T.I. no.: 2024-19 Updated: -	Topic: Software version 2.6.1
---	--------------------------------------

INFORMATION ON BSP 45 AND NEW SOFTWARE VERSION 2.6.1

SOFTWARE VERSION 2.6.1

Figure 2: Pump cycle setting

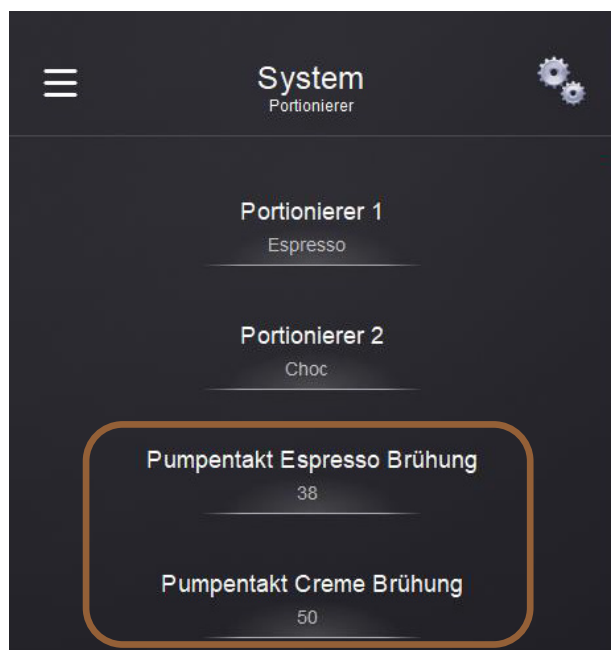
With the new software version, an option for changing the pump cycle and therefore the performance of the oscillating armature pump has been added in order to have additional influence on the brewing time.

The pump cycle can be set separately for all espresso-based and crème-based beverages after entering the service PIN.

System > Portioning device > Pump cycle Espresso brewing (default value38)

System > Portioning device > Pump cycle Crème brewing (default value50)

The **Schaerer Coffee Club** only has two adjustable values for the pump cycle:

- 38 (lower pump performance)
- 50 (higher pump performance)

Figure 3: Option for adjusting the logo

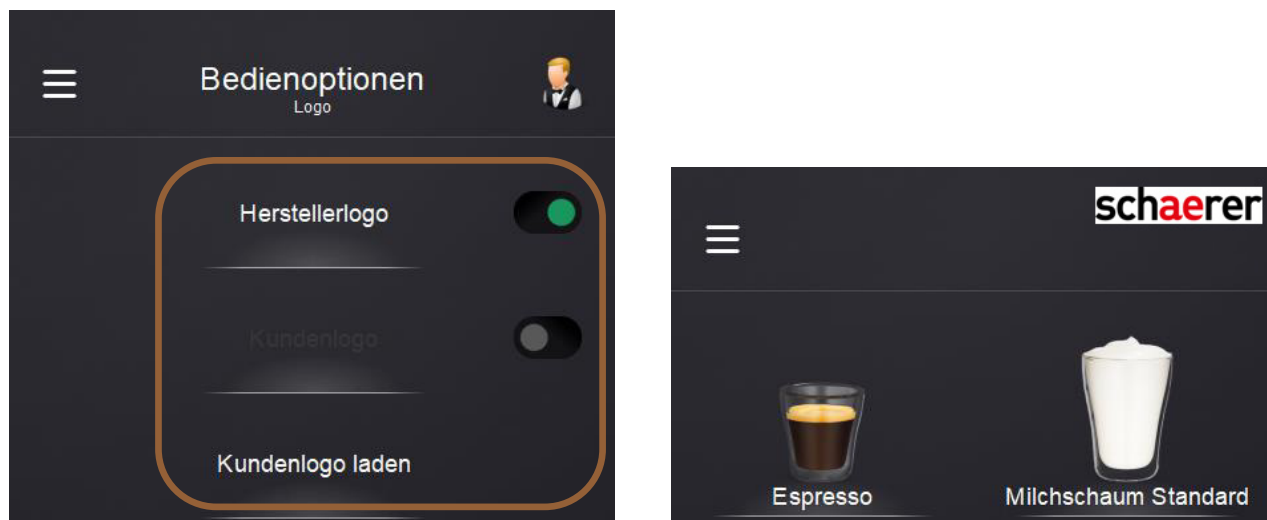
With the new software version, it is possible to show the manufacturer logo and/or a customer logo in the coffee machine display.

The **Customer logo** option is not available until a graphic file with the customer logo has been loaded.

Command options > Logo

The logo must be no higher than a maximum of 80 pixels. Larger logos are automatically scaled to this size.

Figure 5: Override function activated

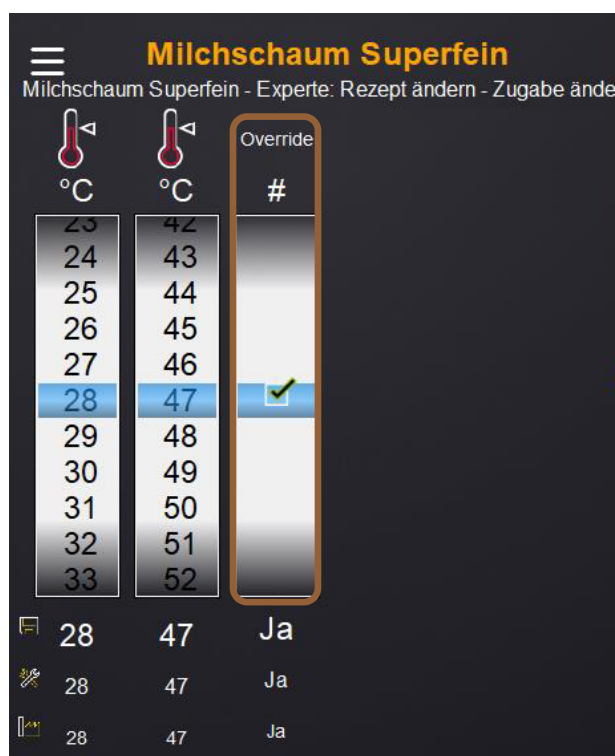
The **SuperSteam** override function did not work with earlier software versions.

Once the temperature set in the recipe had been reached, it was not possible to continue heating when the **SuperSteam** button was pressed.

This behavior is corrected in the new software version.
